SOURCE CONTROL DRAWING

DSC543-1

DRAWN	B. McDONALD	TITLE: SIGN, SELF-ILLUMINATED	DSC 543
CHECKED	W. SIMMONS		
STRESS	B. DE NEEF		
APPROVED	S. HAMID		PAGE 1 OF 2

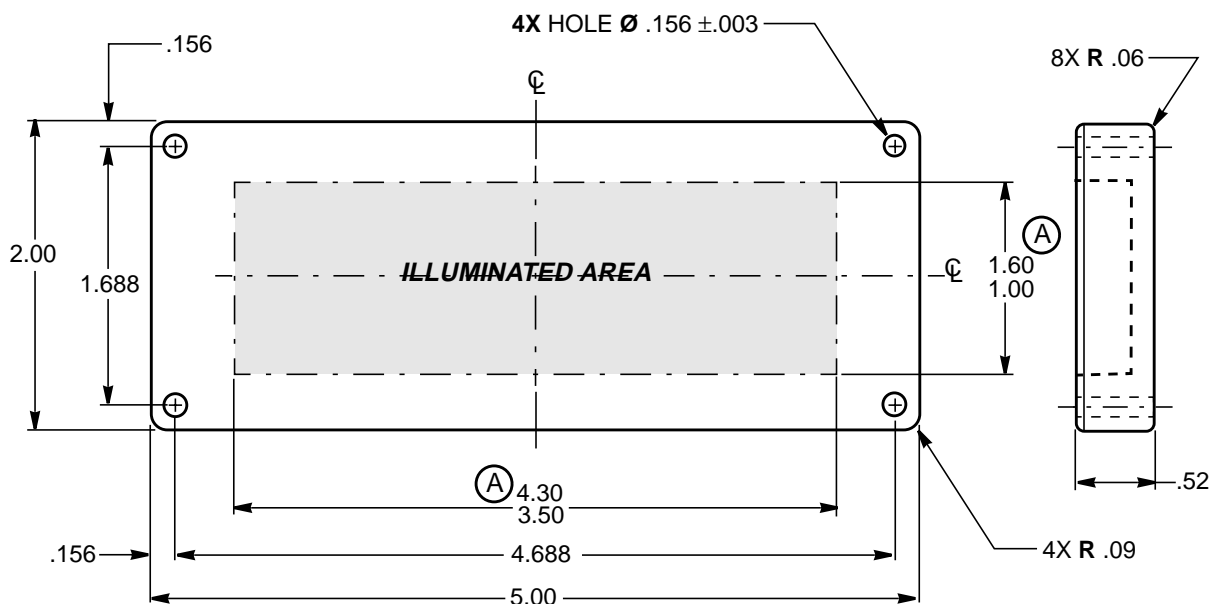
① ILLUMINATED AREA DIM WAS 1.00 X 3.50
NOTE 3 DELETED
